2014/1037/P 10a Oakhill Avenue: Application for 5 flats

I am commenting on this application in respect of its impact on trees and biodiversity.

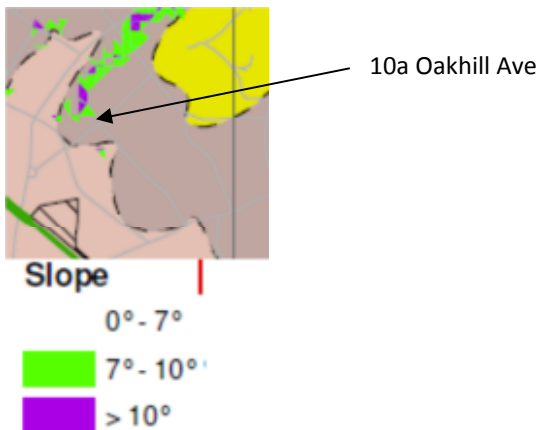
The present building was built too close to T1, the result being too much constraint upon its canopy and frequent Notices of Intent to have its canopy reduced. It would be good if the present block of flats could be set further back to protect the tree in the future. The balcony in particular on the southern (T1 and T8) side of the front of the block will be far too close to the canopy of T1. This

makes complaints and requests to cut the canopy back a possibility. While the tree's RPZ is only slightly affected by the proposed building, I am concerned that the author of the tree report is unaware of this tree's value, and has not been very clear on the need for its protection. I would urge that when a development goes ahead, the developer be encouraged to use a tree expert with experience of veteran trees, and that this person be approved by Camden Tree Officers as someone they know to be good. An excellent example of developers/architects working well in Hampstead is the case of 37a Redington Road – just around the corner. The architects worked well with Camden and made the veteran oak in the front garden the main feature of the development and were sensitive to its needs. We can now continue to appreciate its history and beauty for the lifetime of the house.
